From: [REDACTED]
Cc: [REDACTED]
Subject: RE: TR010027: M42 Junction 6 Improvement - Applegreen plc Deadline 3 Submissions
Date: 15 July 2019 17:16:35
Attachments: [Applegreen DL3 submissions - final.pdf](#)
[Technical Note on Free Flow Junction Alternative for M42 J5a - final.pdf](#)
[Appendices A-E to Applegreens D3 Submissions.zip](#)

APPLEGREEN PLC

**M42 Junction 6
Development Consent Order Application**

Technical Note on Free Flow Junction Alternative for M42 J5a

Title:	Junction 5a Free Flow Alternative Layout
--------	---

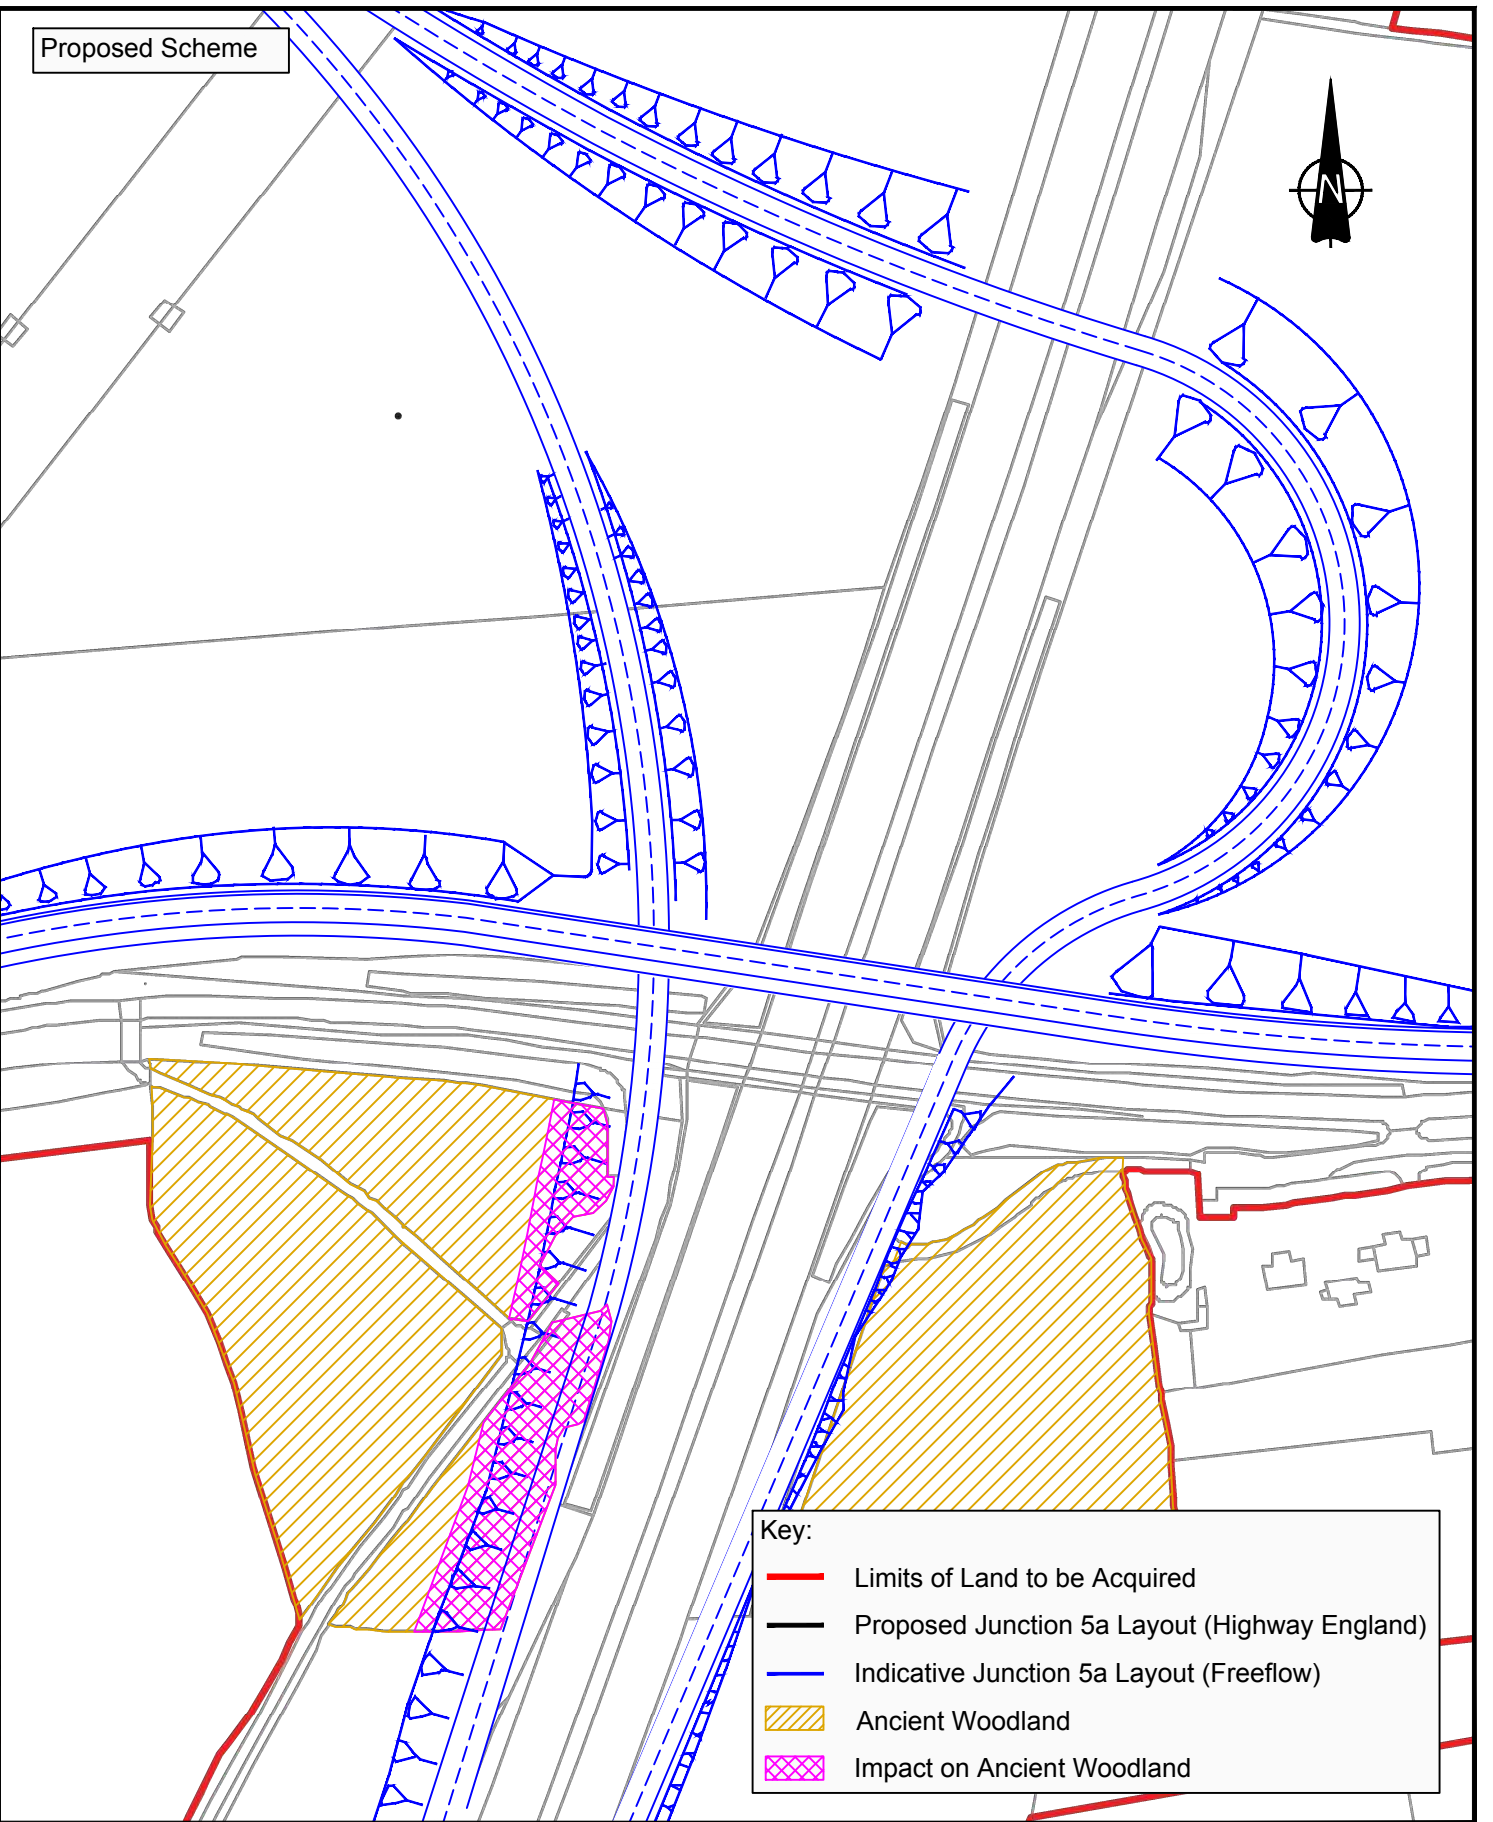
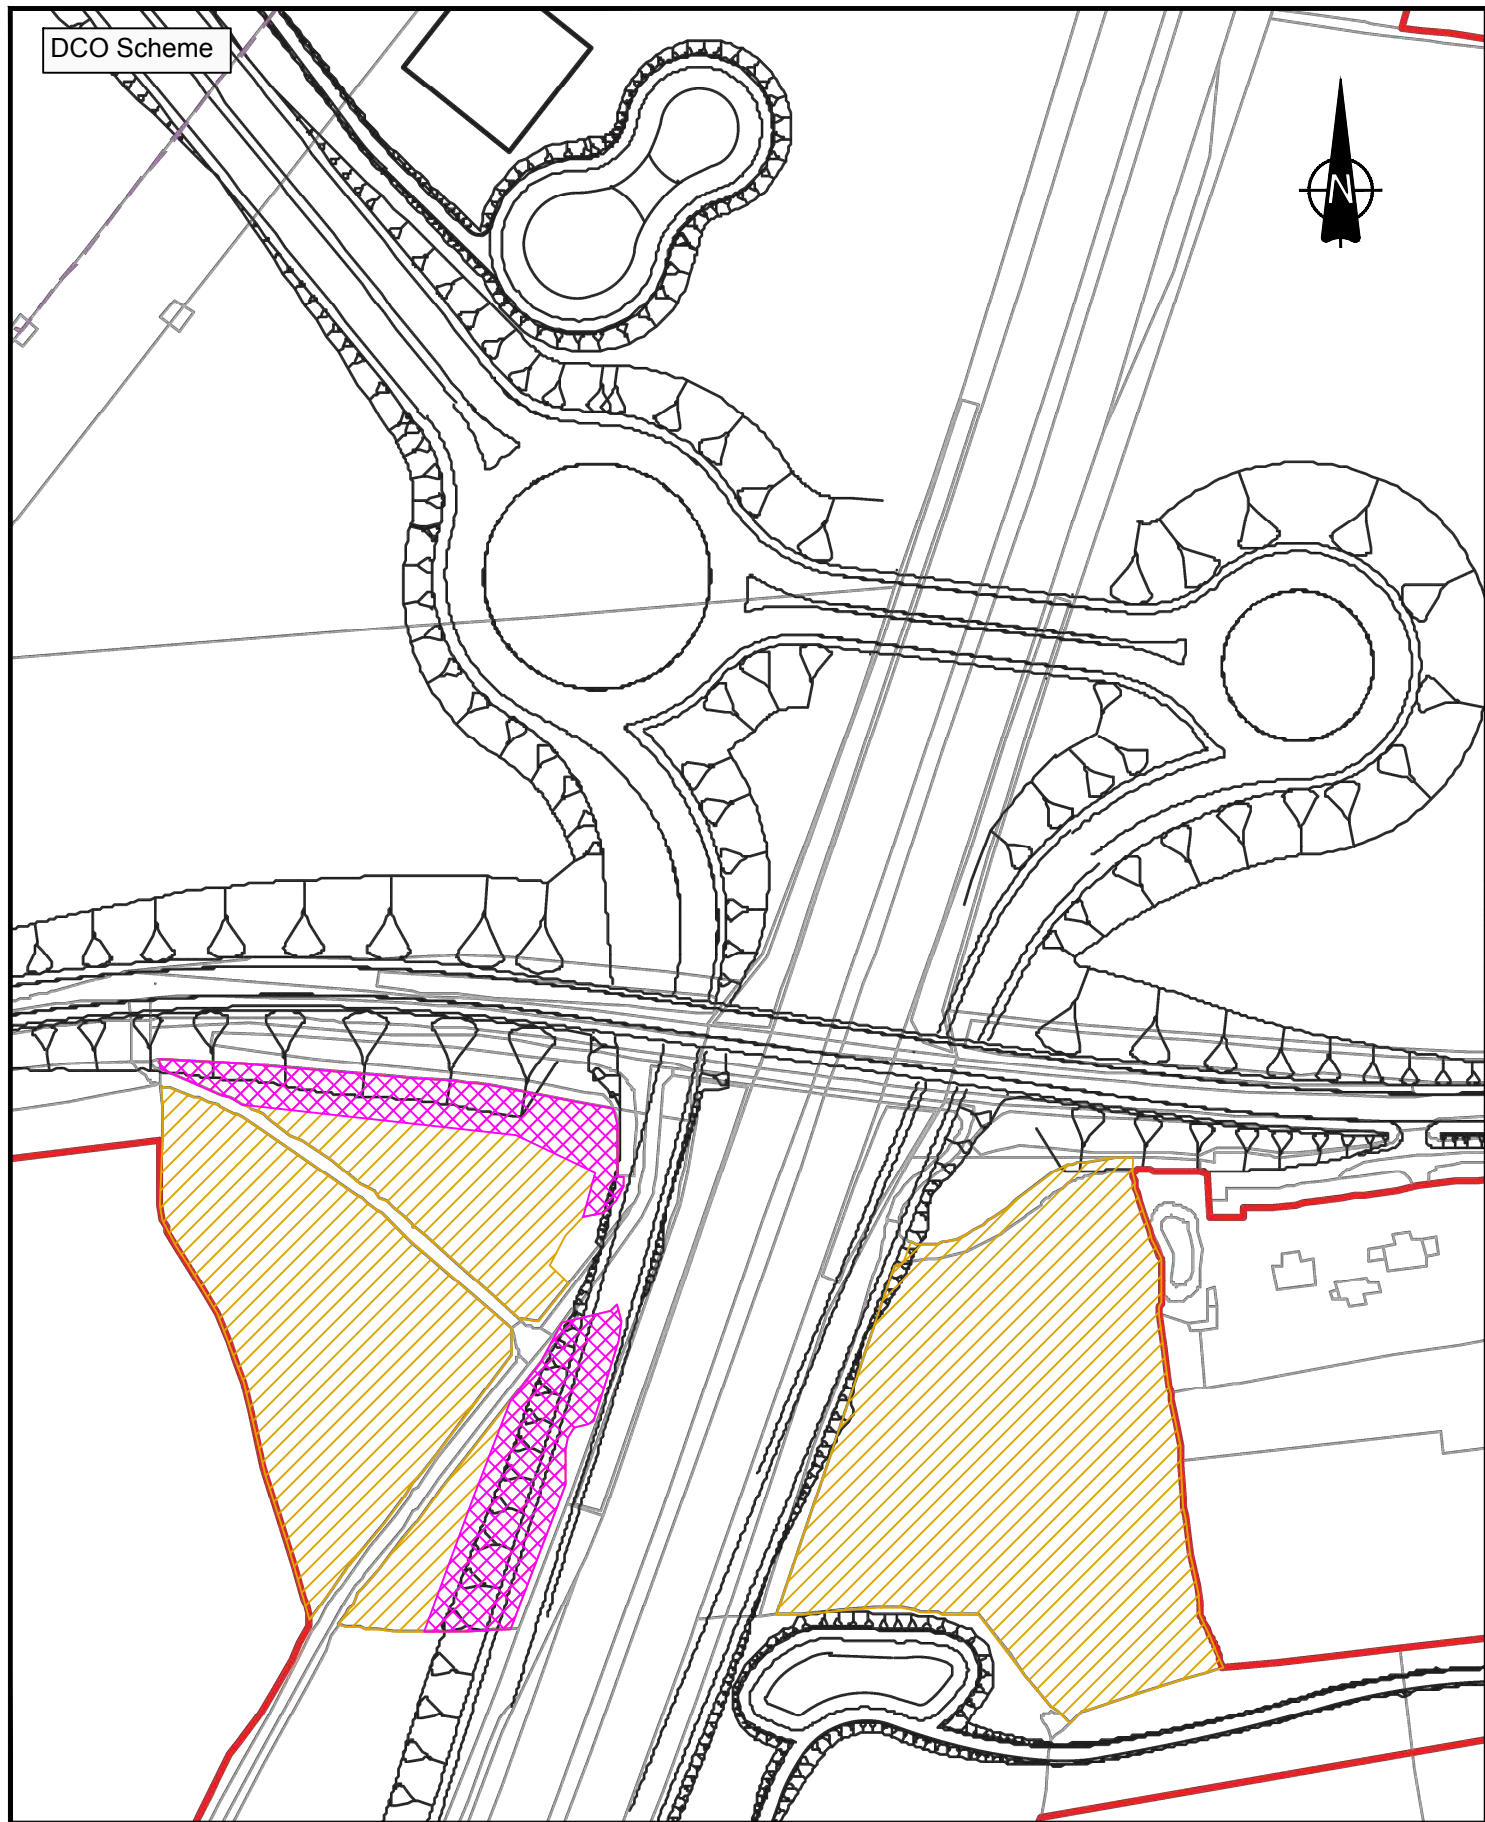
Table 1: Comments on the Applicant's responses (Document 8.6) to the Panel's first written questions			
Question number	Question	Highways England response	Applegreen comment
			<p>Applegreen response:</p> <p>It is assumed that the Applicant is referring to the ability to provide north facing slip roads with the dumb bell arrangement that could not be provided with the free flow arrangement. However, the Applicant has made it clear that the north facing slip roads were not included in the DCO scheme because of the safety risks associated with the close proximity to Junction 6 and the lack of traffic demand. It is therefore paradoxical to compromise the layout of an improvement scheme in order to retain the option to introduce slip roads that have already been determined by the Applicant to be unsafe. It is simply not the case that the draft DCO provides the "optimum junction arrangement" as the Applicant claims. It has been demonstrated through the design at Appendix A that more preferable improvement options exist.</p>

Title:	Relative Impact on Ancient Woodland
--------	-------------------------------------

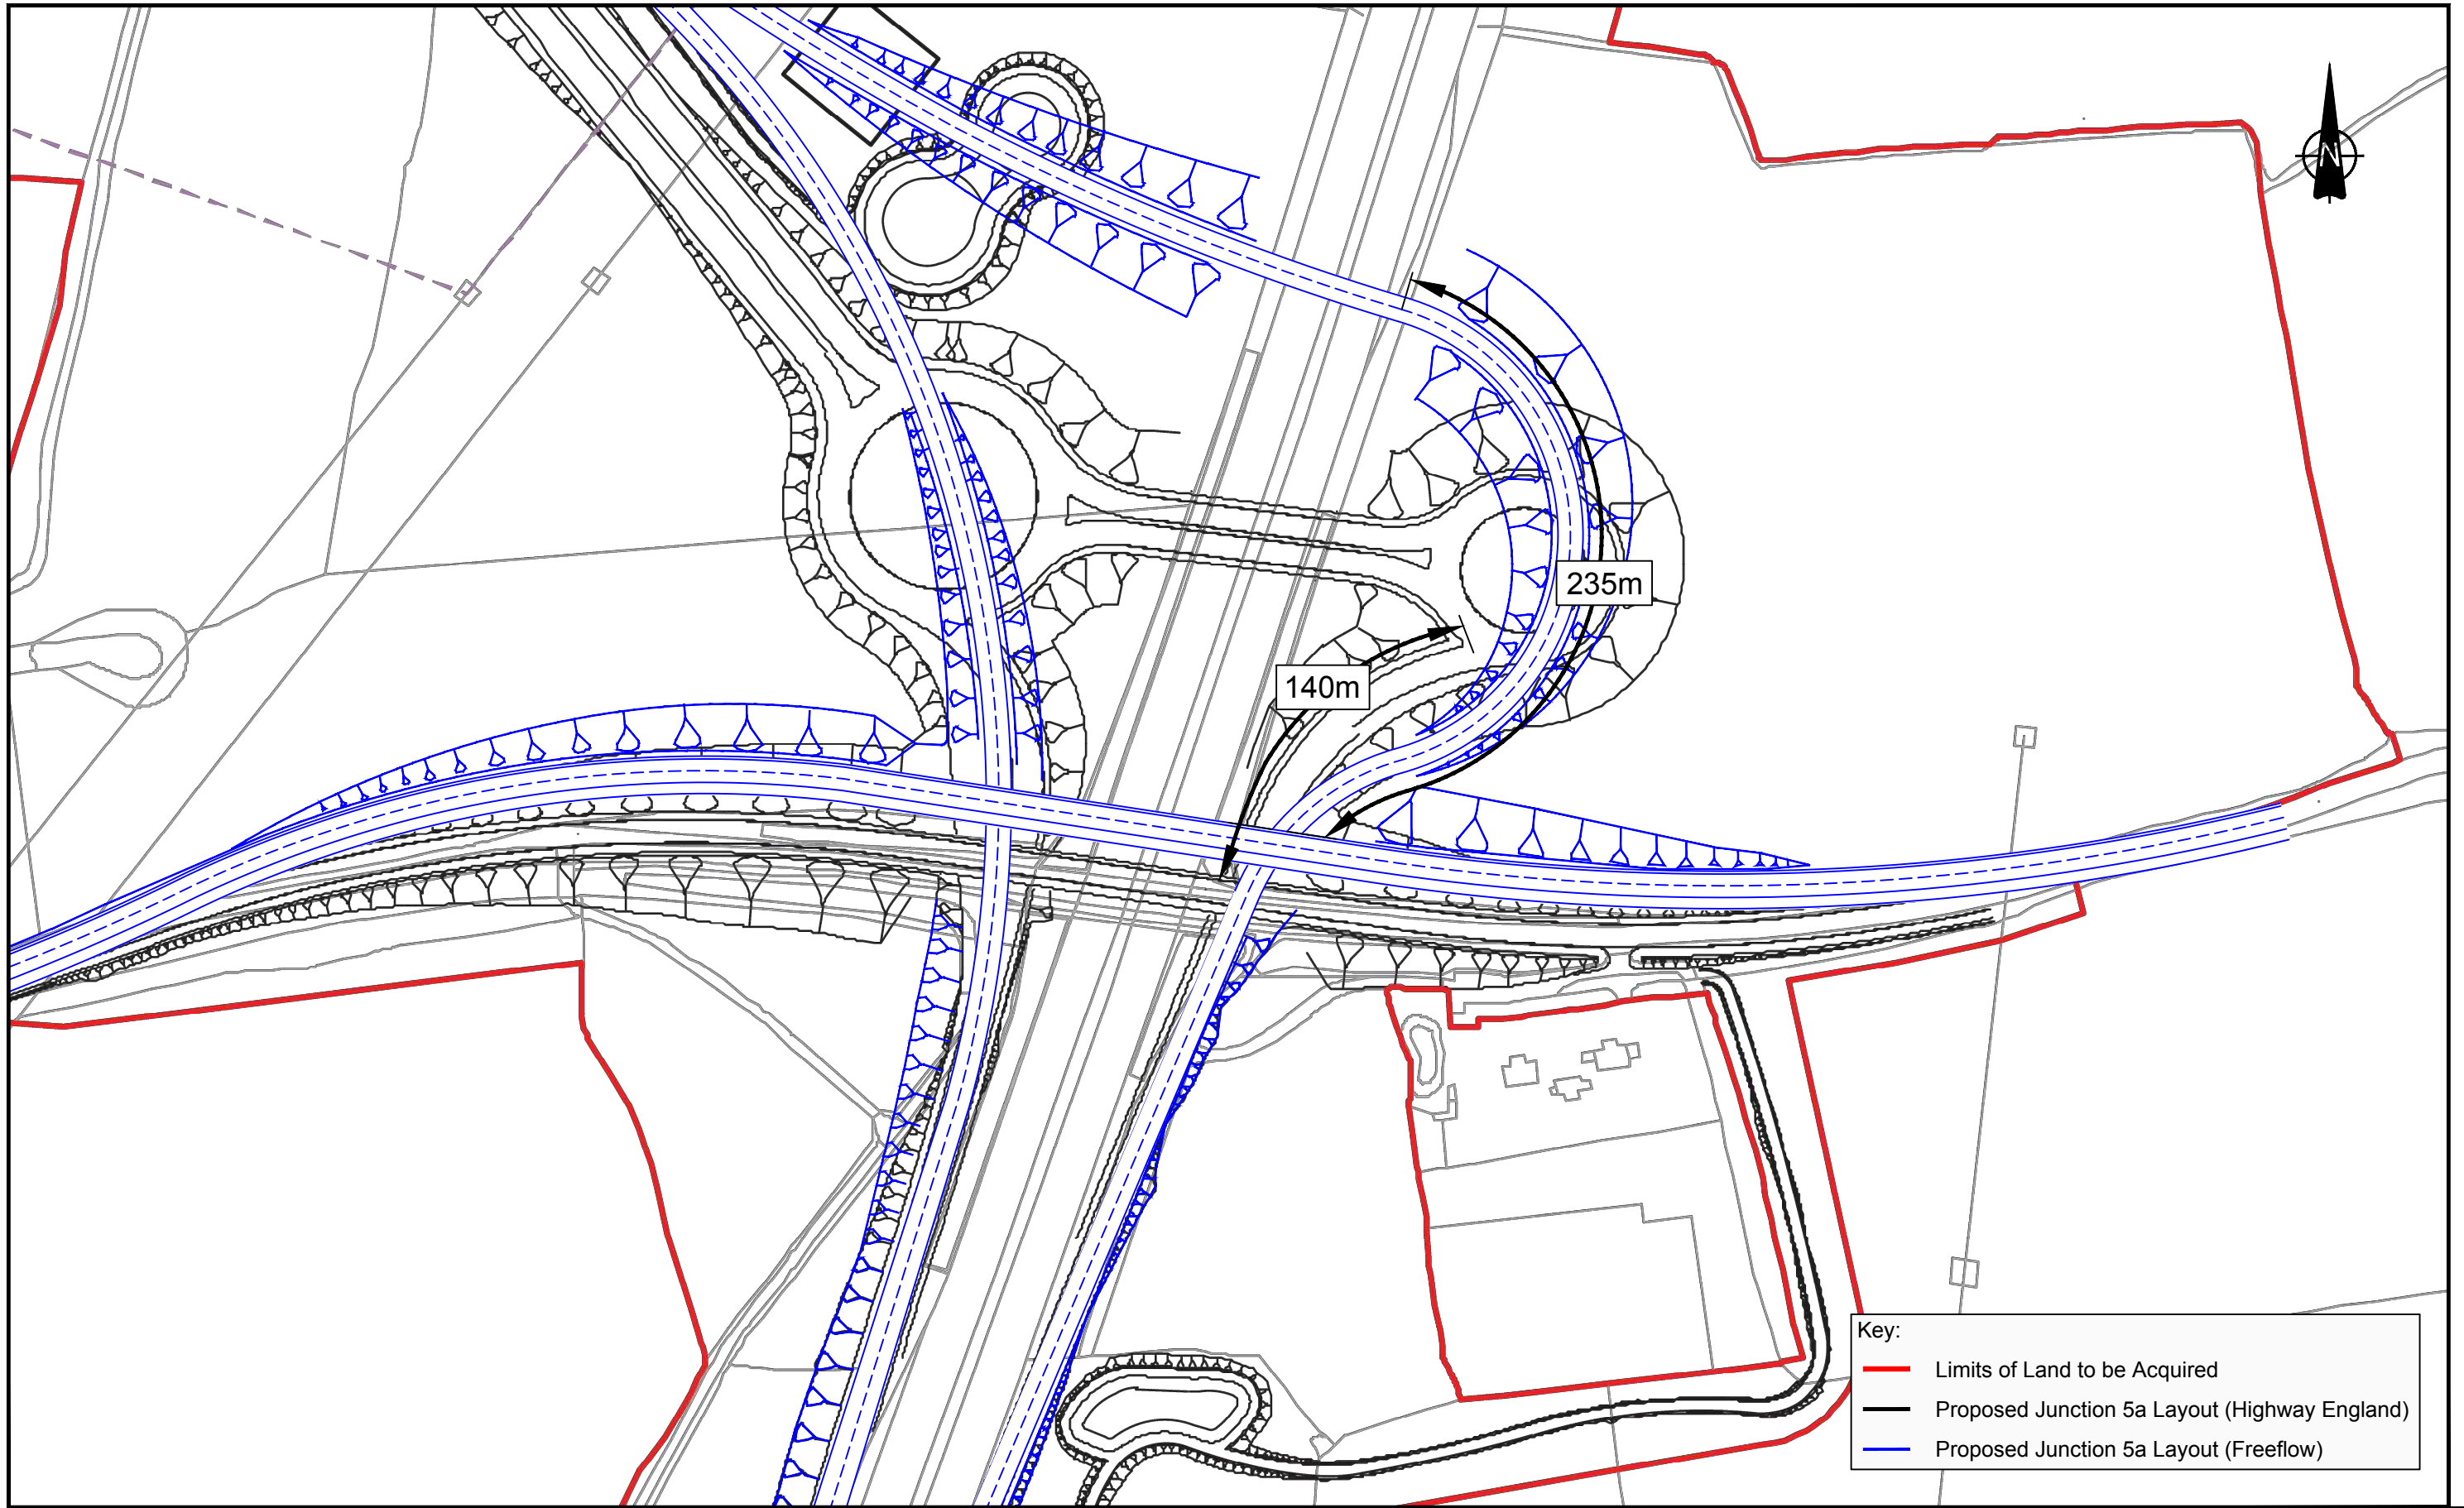
Question number	Question	Highways England response	Applegreen comment
			<p>on the ancient woodland. Applegreen's consultants have undertaken an assessment of the relative impact of the two options on the ancient woodland to the west of the motorway and this is detailed in Appendix B. The relative areas taken from these sketches show that the free flow alternative would have 23% less impact on the area of ancient woodland to the west of the motorway than the DCO scheme.</p> <p>3. Would require less diversion of statutory undertakers apparatus.</p> <p>Applegreen response:</p> <p>The Applicant has not identified the statutory undertakers apparatus they are referring to but the free flow scheme could be constructed without impacting on the overhead power lines. We are not aware of any other utilities' constraints.</p> <p>4. Safer conditions for maintenance workers.</p> <p>Applegreen response:</p> <p>It is not clear why the Applicant considers this to be the case .</p> <p>5. The published dDCO layout provides inherent flexibility to allow improved access to the road network for future local and regional growth.</p>
